Entergy Nuclear Operations, Inc.
(Indian Point Nuclear Generating Units 2 and 3)

PRE-FILED SUPPLEMENTAL REPLY WRITTEN TESTIMONY OF

Dr. RICHARD T. LAHEY, JR.

REGARDING CONSOLIDATED CONTENTION NYS-26B/RK-TC-1B

Figure 1: Comparison of Limit Line (LL) and Best Estimate (BE) predictions, with embrittlement (BE_e) and without embrittlement (BE_{ne}).

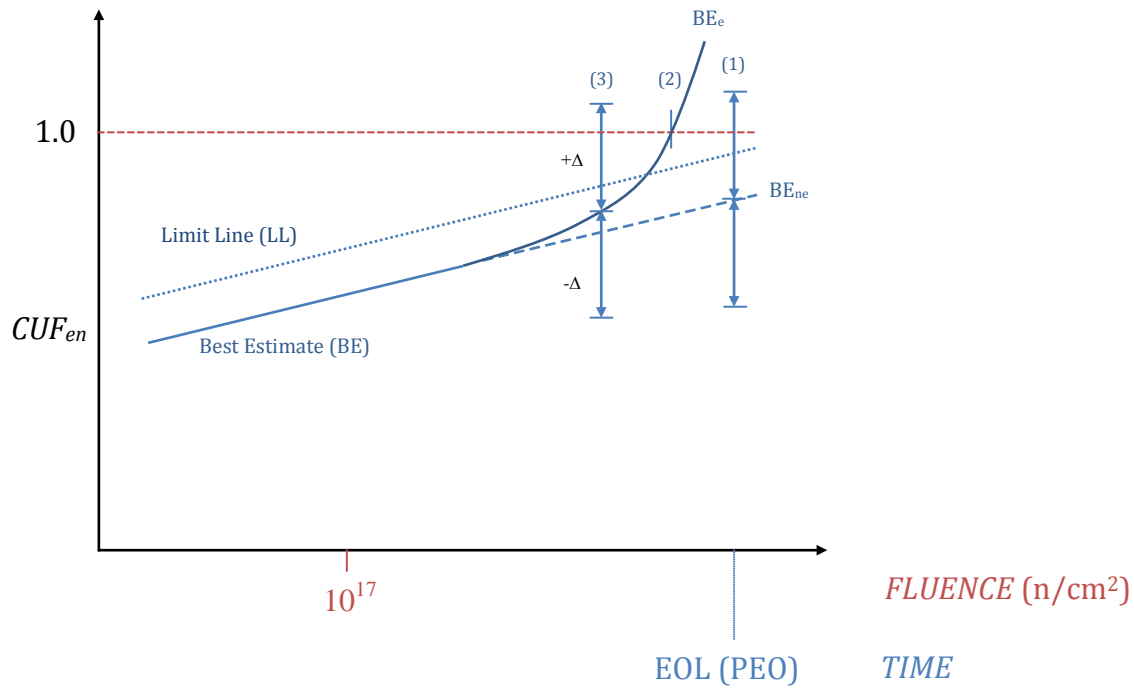
2 A. I prepared this Figure to visually illustrate some of
 3 the concerns that I have set forth in my testimony in this
 4 proceeding. Specifically, this Figure shows three important
 5 things: (1) a typical WESTEMS™ "Limit Line" prediction, (2) a
 6 "Best Estimate" prediction of CUF_{en}, the cumulative usage factor
 7 under reactor operating conditions, and the associated

11 A. Not necessarily. As shown in Figure-1, a "Best
12 Estimate" prediction plus the uncertainty (Δ) may predict
13 possible RVI structure, components or fitting failures (i.e.,
14 $CUF_{en} = 1.0$), sooner than the "Limit Line" would. Moreover, the
15 effect of embrittlement can make the situation much worse. The
16 problem is that no one knows how much conservatism, if any, is
17 in the [REDACTED] "Limit Line". As a consequence, we can have no
18 confidence that "Limit Line" results near $CUF_{en} = 1.0$, are
19 sufficiently conservative to bound all the possible
20 uncertainties, as illustrated in Figure-1 by Δ .

20 A. Location (1) shows that, even if embrittlement is not
21 considered, RVI fatigue failure may occur by the end of life for
22 the period of extended operation. This is because the sum of a

1 "Best Estimate" prediction plus the uncertainty interval (Δ)
2 associated with this prediction would exceed $CUF_{en} = 1.0$. In this
3 case the "Limit Line" result is clearly non-conservative.

6 A. Location (2) shows that embrittlement can result in
7 the physical failure of the RVI well before the end of life for
8 the period of extended operation.

11 A. At location (3), the "Best Estimate" plus uncertainty
12 (Δ) for the case considering embrittlement (BE_e) predicts
13 possible failure of the hypothetical RVI component well before
14 the end of life for the period of extended operation, even
15 though the "Limit Line" prediction indicates substantial margin
16 to failure at this point. That is, at location (3) the CUF_{en} for
17 the "Best Estimate" line, accounting for embrittlement and for
18 all uncertainties (i.e., $BE_e + \Delta$), exceeds unity. Moreover, as I
19 have stated in my previous testimony, highly embrittled RVIs may
20 fail even sooner than by fatigue alone if significant seismic or
21 shock loads occur. That is, fatigue-weakened and embrittled
22 structures cannot tolerate large impulsive seismic and shock
23 loads like fully ductile structures can. Moreover, other

1 synergistic aging effects, such as the thermal embrittlement (TE)
2 of some CASS RVIs (the upper part of the core support columns)
3 would may move the BE_e curve to the left of its position shown in
4 Figure-1 (i.e., the RVI would be predicted to reach failure,
5 $CUF_{en} = 1.0$, even sooner than the cases (2) and (3) in Figure-1).

8 A. Yes. Because of Entergy's failure to explicitly
9 account for uncertainties, and for the effect of embrittlement
10 on fatigued RVIs, we can have no confidence in the "Limit Line"
11 type of CUF_{en} predictions [REDACTED]
